UNITED STATES
NUCLEAR REGULATORY COMMISSION
WASHINGTON, D.C. 20555-0001

SUBJECT: MONTICELLO NUCLEAR GENERATING PLANT - STAFF ASSESSMENT OF INFORMATION PROVIDED PURSUANT TO TITLE 10 OF THE *CODE OF FEDERAL REGULATIONS* PART 50, SECTION 50.54(f), SEISMIC HAZARD REEVALUATIONS FOR RECOMMENDATION 2.1 OF THE NEAR-TERM TASK FORCE REVIEW OF INSIGHTS FROM THE FUKUSHIMA DAI-ICHI ACCIDENT (TAC NO. MF3958)

STAFF ASSESSMENT BY THE OFFICE OF NUCLEAR REACTOR REGULATION

MONTICELLO NUCLEAR GENERATING PLANT

Figure 3.3-1 Plot of Staff's and Licensee's Base Case Shear-Wave Velocity Profiles for the Monticello Site

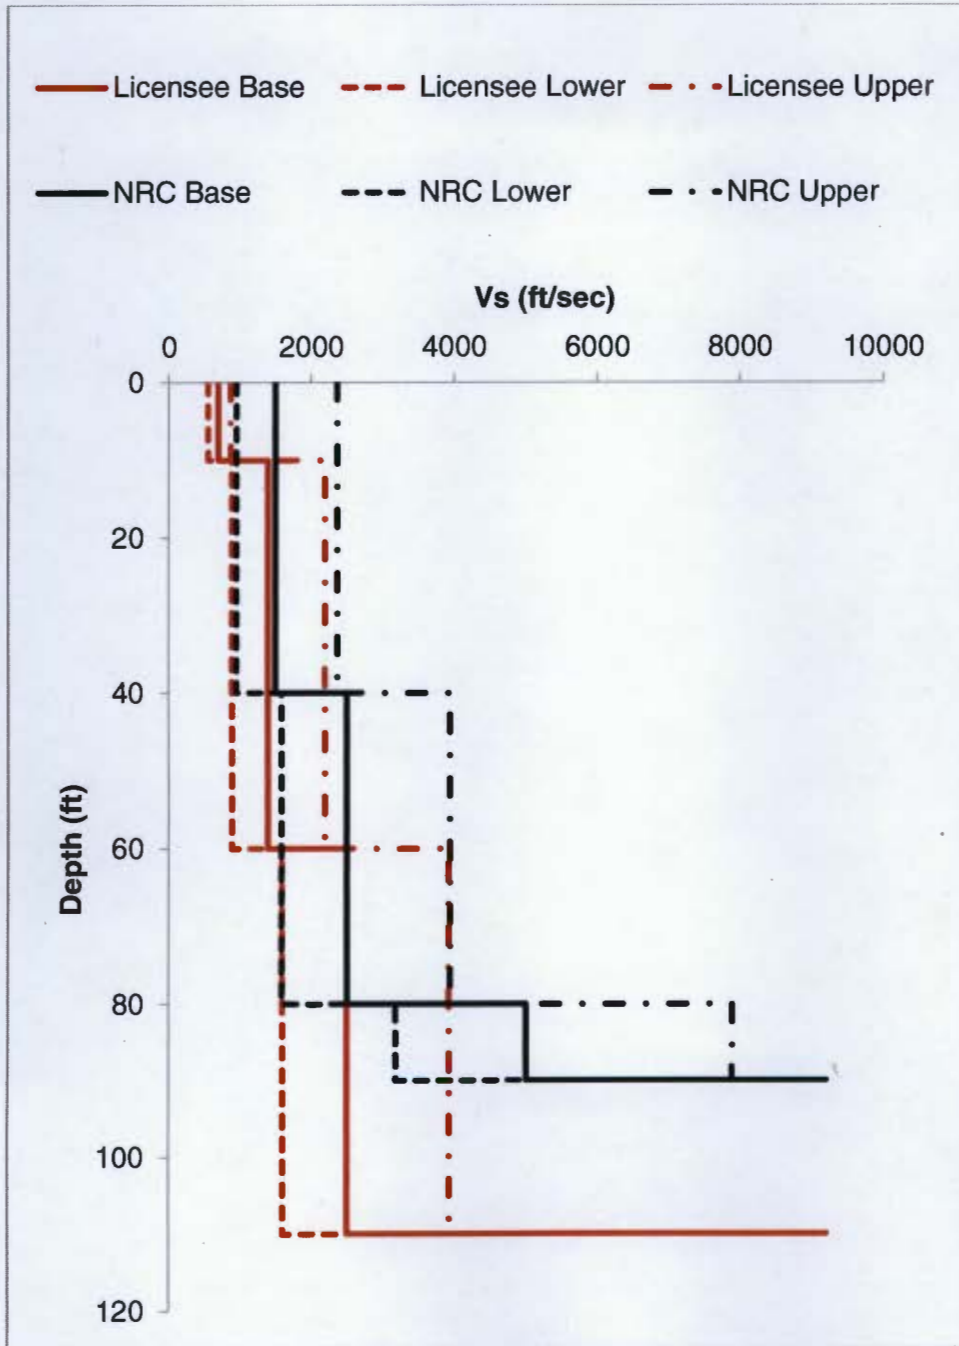
The staff performed independent calculations to confirm that the licensee's amplification factors and control point hazard curves adequately characterize the site response, including the uncertainty associated with the subsurface material properties, for the Monticello site. The staff independently developed three base case shear-wave velocity profiles from information provided in the USAR. The staff's base case shear-wave velocity profiles are shown along with the licensee's base case profiles in Figure 3.3-1 of this assessment. The staff's shear wave velocity profiles agree with those submitted by the licensee with only a minor difference in the estimated depth to bedrock.

Figure 3.3- 1 Plot Comparing the Staff's and the Licensee's Median Amplification Functions and Uncertainties for the Monticello site.

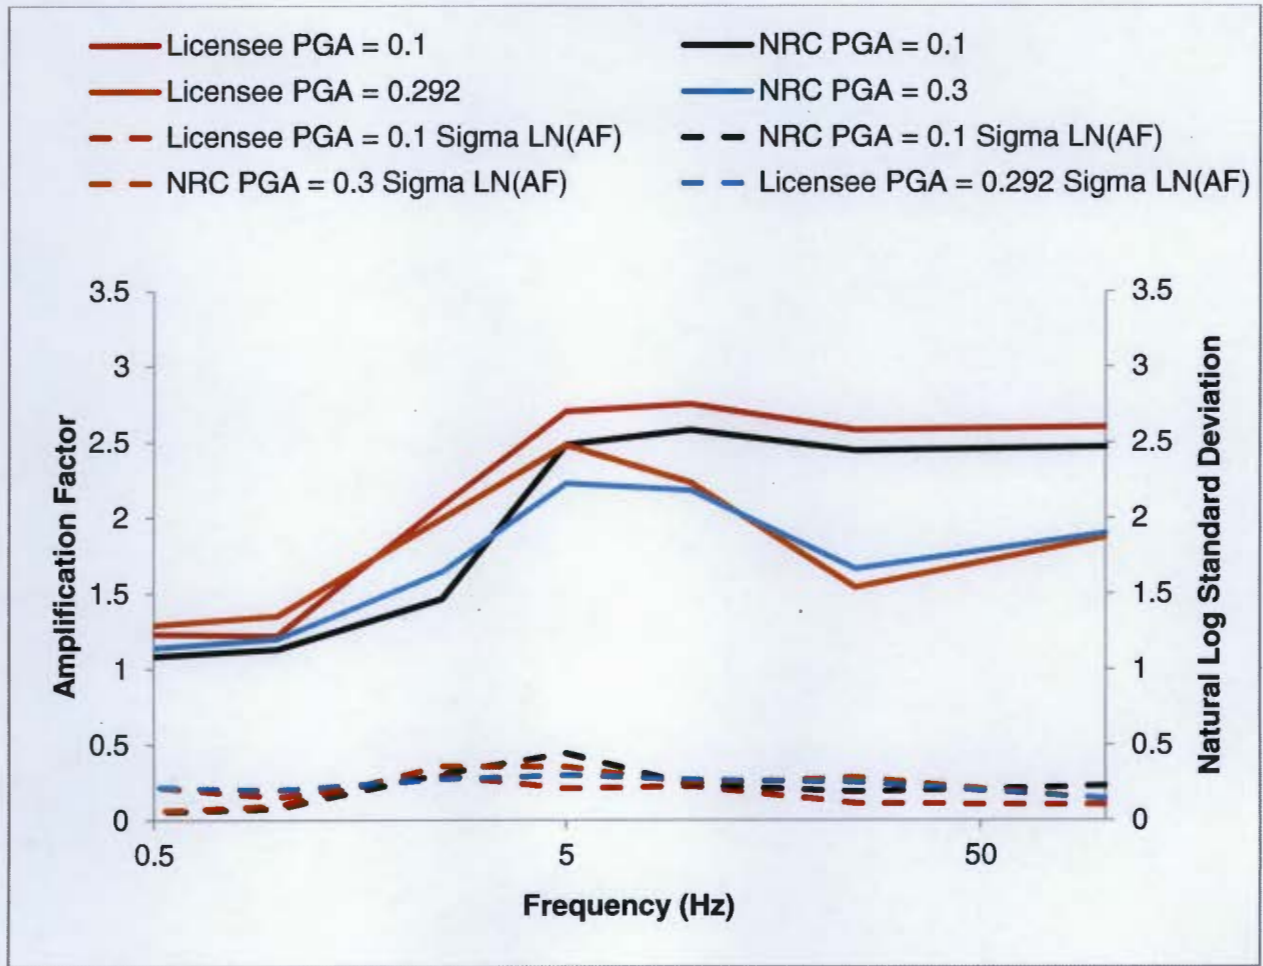
In order to calculate control point hazard curves for the Monticello site, the licensee and staff developed median amplification functions for the site for several different loading levels, representing the possible hazard at the Monticello site. The licensee's and staff's median site amplification functions and associated uncertainty for two separate loading levels are shown in Figure 3.3-2 of this assessment. It can be seen that both the staff's and licensee's site amplifications are similar in shape with only a slight differences for the higher frequencies. Figure 3.3-3 of this assessment shows the licensee's and staff's control point hazard curves resulting from the convolution of the site amplification with the PSHA rock hazard curves. As shown in Figure 3.3-3, the licensee's and staff's results are very similar.

Figure 3.4-1 Comparison of the Staff's GMRS with Licensee's GMRS and the SSE for the Monticello site

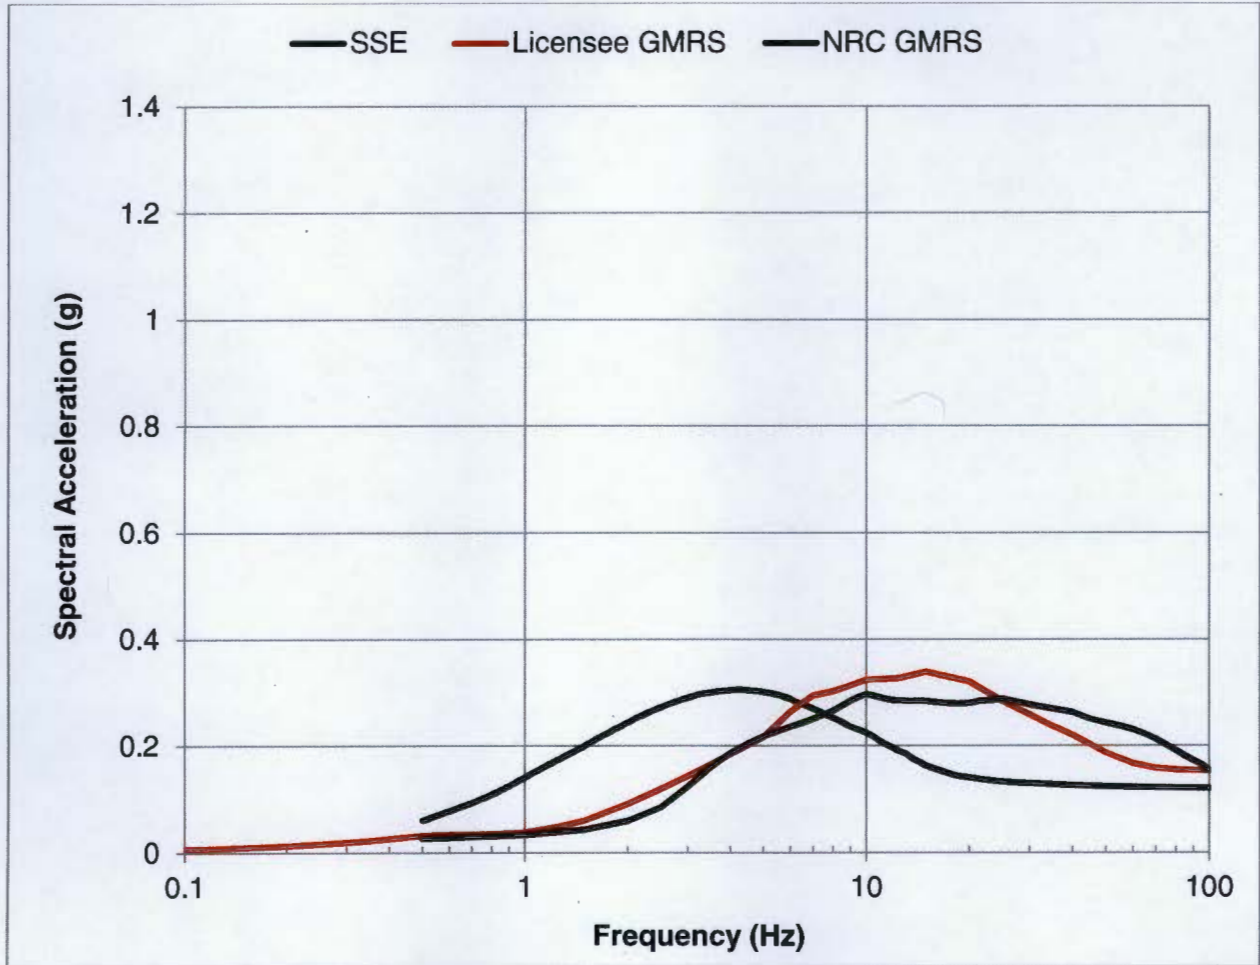
The NRC staff independently calculated the 10^{-4} and 10^{-5} UHRS using the results of its confirmatory PSHA and site response analysis, as described in Sections 3.2 and 3.3 of this staff assessment, respectively. Figure 3.4-1 of this assessment shows a comparison of the GMRS determined by the licensee to that determined by the staff. As shown in Figure 3.4-1 below, the licensee's GMRS shape is generally similar to that calculated by the staff. At frequencies where the amplitude of the GMRS determined by the licensee is different from that determined by the staff, the licensee's generally exceeds that of the staff. These differences in GMRS are the result of differences in the site response analyses performed by the licensee and staff as discussed in Section 3.3 above. The NRC staff concludes that these differences are acceptable for this application because the licensee followed the guidance provided in the SPID with respect to both the PSHA and site response analysis for the Monticello site.

In reaching this determination, the NRC staff confirmed the licensee's conclusion that the licensee's GMRS exceeds the SSE for the Monticello site in the frequency range of 1 to 10 Hz, and also in the frequency range above 10 Hz. As such, a seismic risk evaluation, SFP evaluation and high-frequency confirmation are merited. The licensee indicated that the high frequency confirmation would be performed as part of its seismic risk evaluation. The NRC review and acceptance of the NSPM plant seismic risk evaluation with the high frequency confirmation, and also an interim ESEP evaluation and SFP evaluation (i.e., Items (4), (6), (8), and (9)) for Monticello will complete Seismic Hazard Evaluation identified in Enclosure 1 of the 50.54(f).
